Toolern PSP & DCP Review

Amendment C232Melt

Transport Engineering Evidence

Melton City Council

Figure 5: Toolern DCP (June 2022) Benchmark Design, Ferris Rd V191096-CI-DG-2008-2 (25.4m)

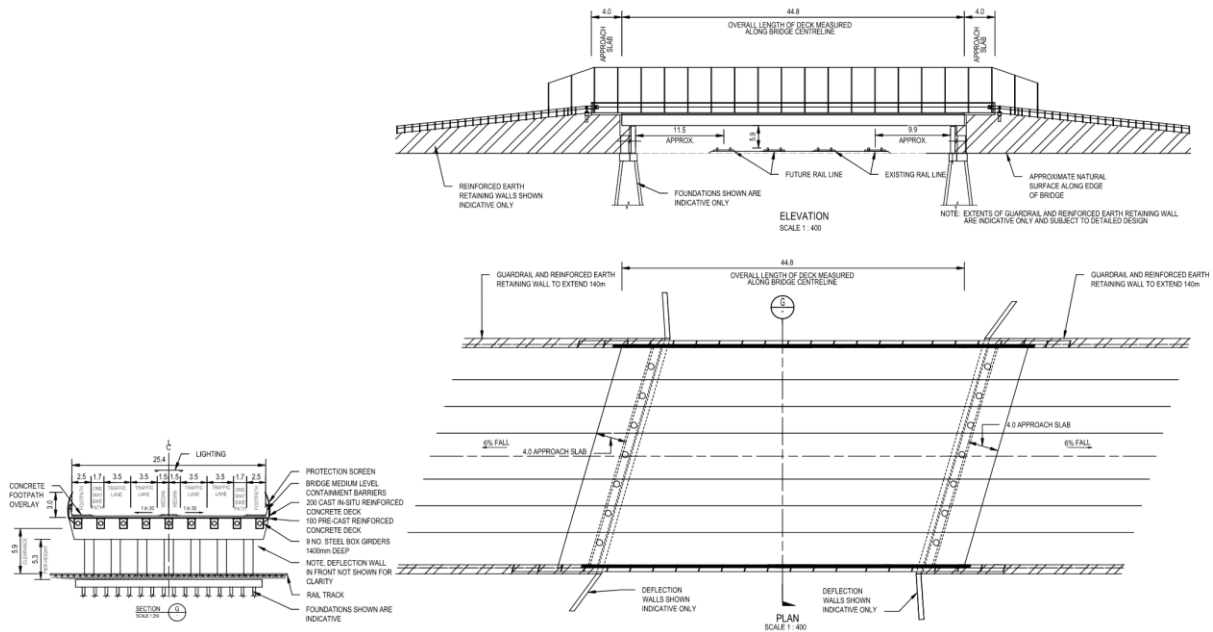
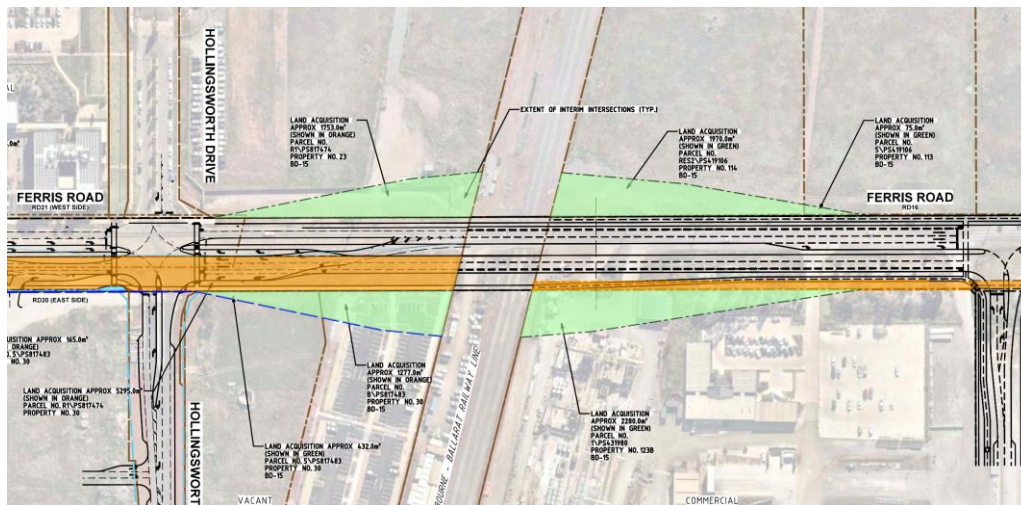
The Toolern DCP identifies the Ferris Rd and East Road rail over passes as BD15 and BD16 respectively, however there is an error in bridge ID numbers presented on DCP drawings V191096-CI-DG-2007-2 (sheet 101) & V191096-CI-DG-2008-2 (sheet 102). The detail for the Ferris Road rail overpass bridge is shown on DCP drawing V191096-CI-DG-2008-2 (sheet 102) and includes 4 lanes within a cross section width of 25.4m, as shown in Figure 5.

The land take drawings provided within the Toolern DCP for the Ferris Rd rail overpass were prepared assuming the provision for earth batters rather than retaining walls as shown in Figure 7.

Figure 13: Paynes Road PSP (2016), Secondary Arterial 4 lane (Paynes Rd), 34m

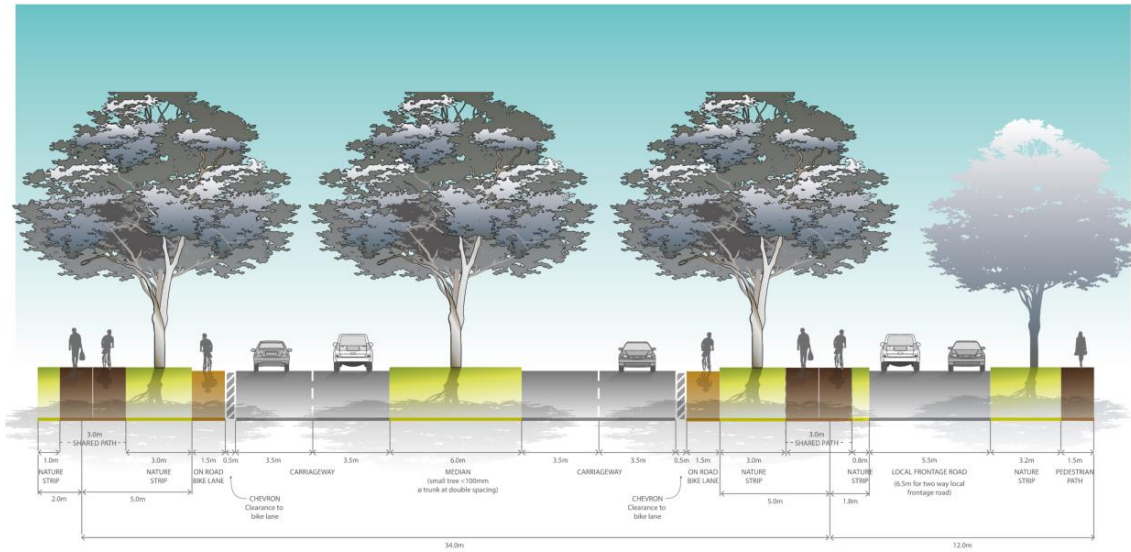
Road	Lanes (Ultimate)	Cross Sections <i>Source Toolern PSP (June 2022)</i>	Note
Abey Rd RD18	4		
Paynes Rd RD22 to 24	4		Reserve width of 34m consistent with 2016 Paynes Rd PSP, refer Figure 13
Toolern Rd (west of Mt Cottrell Rd) RD05 to 07	4		Reserve width of 34m Figure 13
Toolern Rd (east of Mt Cottrell Rd) RD08	4		Reserve width of 34m (Excl 11m nature strip) consistent with Rockbank PSP, refer Figure 9 Figure 13
Exford Rd RD01, 03 & 04	4		Reserve width consistent with Toolern Rd (west of Mt Cottrell Rd)
Exford Rd RD02	4		Reserve width consistent with Toolern Rd (west of Mt Cottrell Rd)

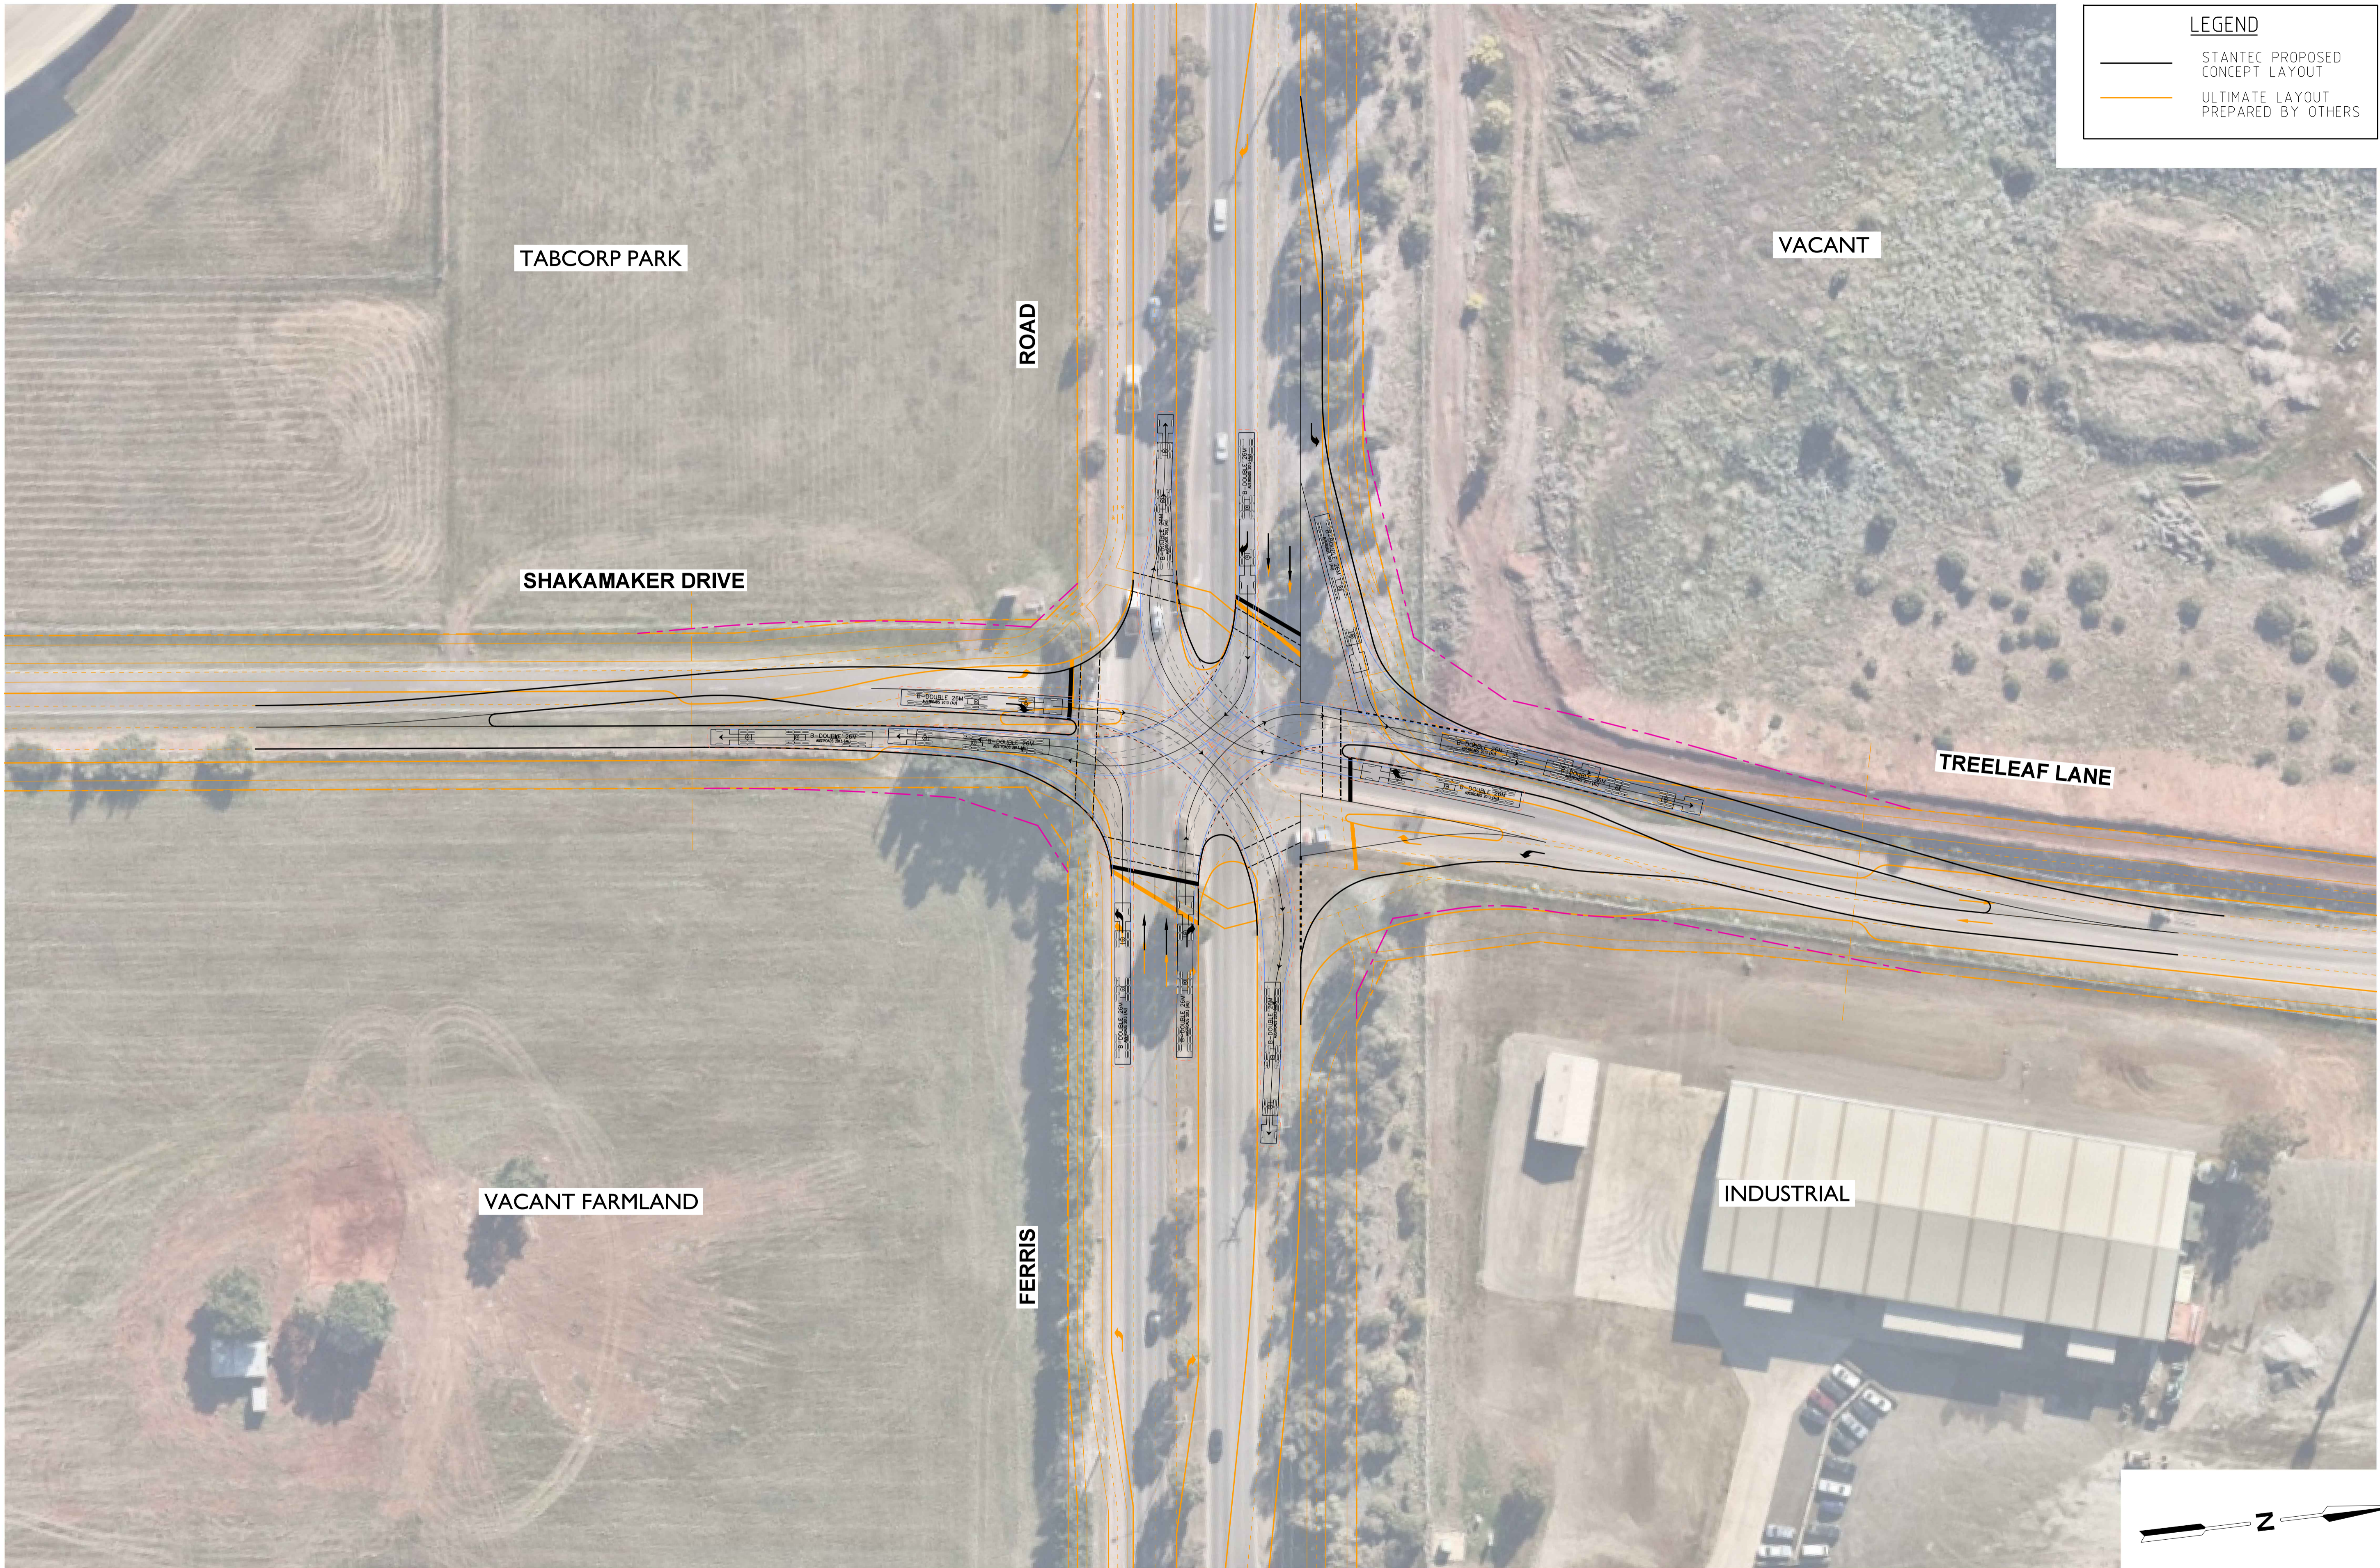
The intersection layout (IT18) and operational constraints are undesirable and there is opportunity through further design development to provide an improved outcome.

8. The layout and operational compromises adopted for the intersection of Ferris Rd / Shakamaker Rd / Treeleaf Lane (IT18) is undesirable and there is opportunity through further design development to provide an improved outcome. It is my opinion that the amended design included in Appendix B should be incorporated into the PSP.
